# IODP Proposal Cover Sheet

708 - Add 3

Central Arctic Paleoceanography

## **Addendum to Proposal 708-Full1 ("Add4"; 06 March 2020)**

Figure 2. Form 6 of Site LR-04C

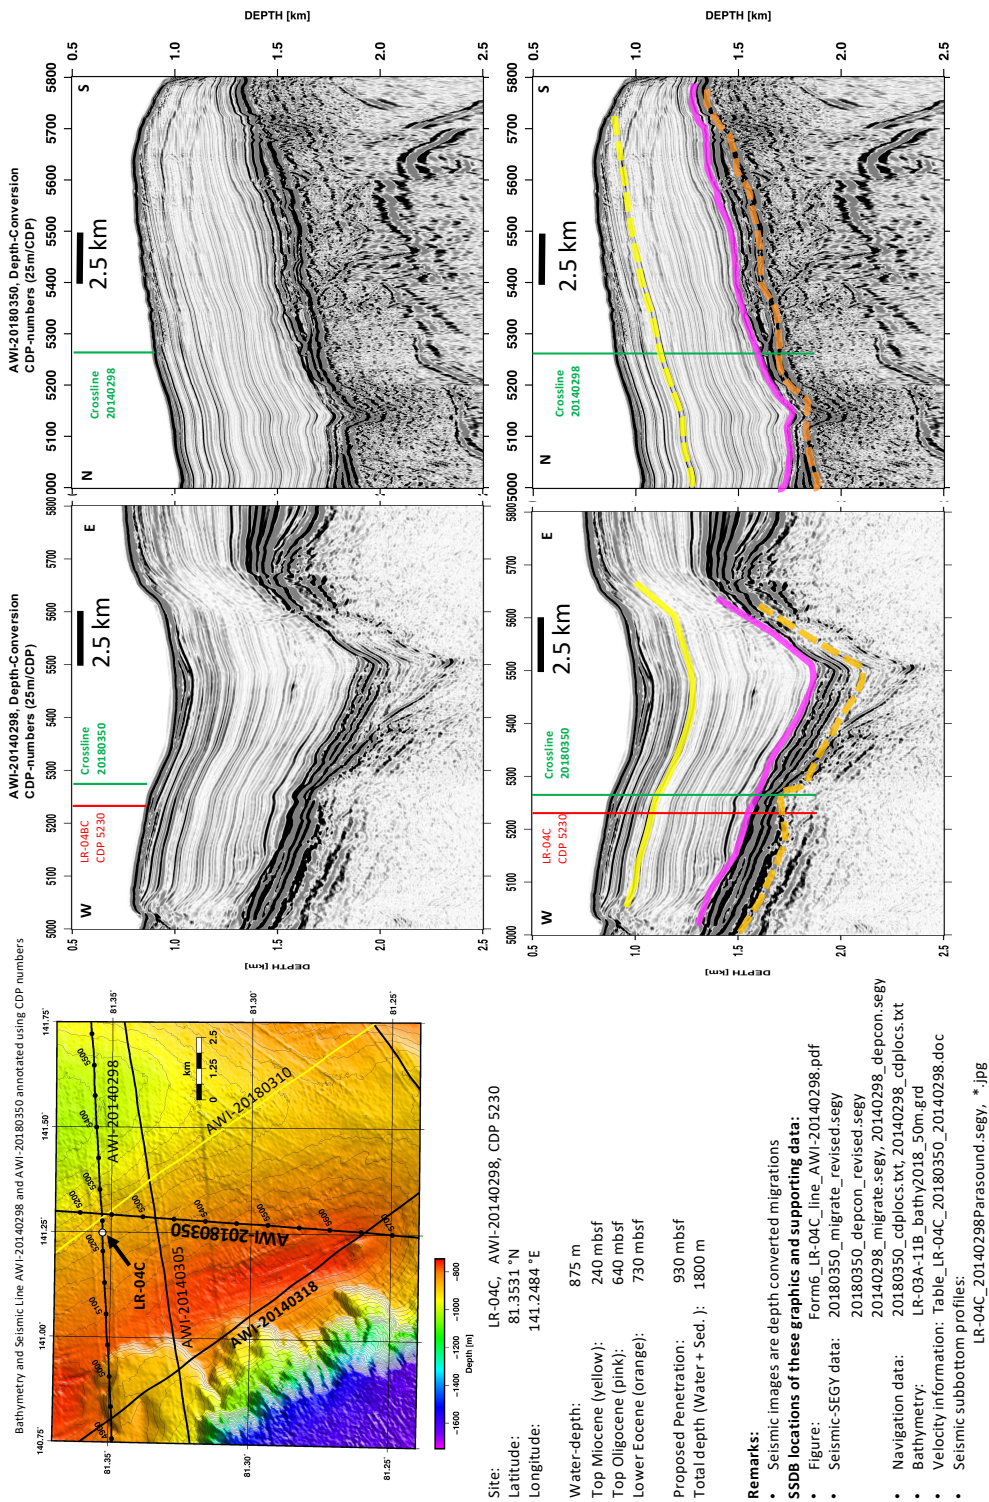
**This addendum is an update of the previous Addendum (708-Add3). It is to slightly relocate the sites LR-04B and LR-10A, responding to EPSP review on 18/19 February 2020. The names of these relocated sites have been changed into LR-04C and LR-10B. No further changes have been made.**

The updates of sites LR-04C and LR-10B (for location see Fig. 1) are included in Table 1, summarizing the data of all our proposed sites. We select the new Site LR-11B as primary deep site and LR-10A as primary shallow site, all other sites (i.e., LR-01A, LR-02A, LR-03A, LR-04C, LR-05B, LR-06A, LR-07A, LR-08A, LR-09A, and LORI-5B) remain active alternate sites. All alternate sites at which the target depth can be reached with total drill pipe length no longer than 2000 m, are highlighted in Table 1 in yellow. For the relocated and renamed sites LR-04C and LR-10B the revised "Form 6" are included here as Figures 2 and 3, respectively.

As demanded, the locations of sites LR-04B and LR-10A were shifted to LR-04C and LR-10B, respectively. New or revised values are marked in green.
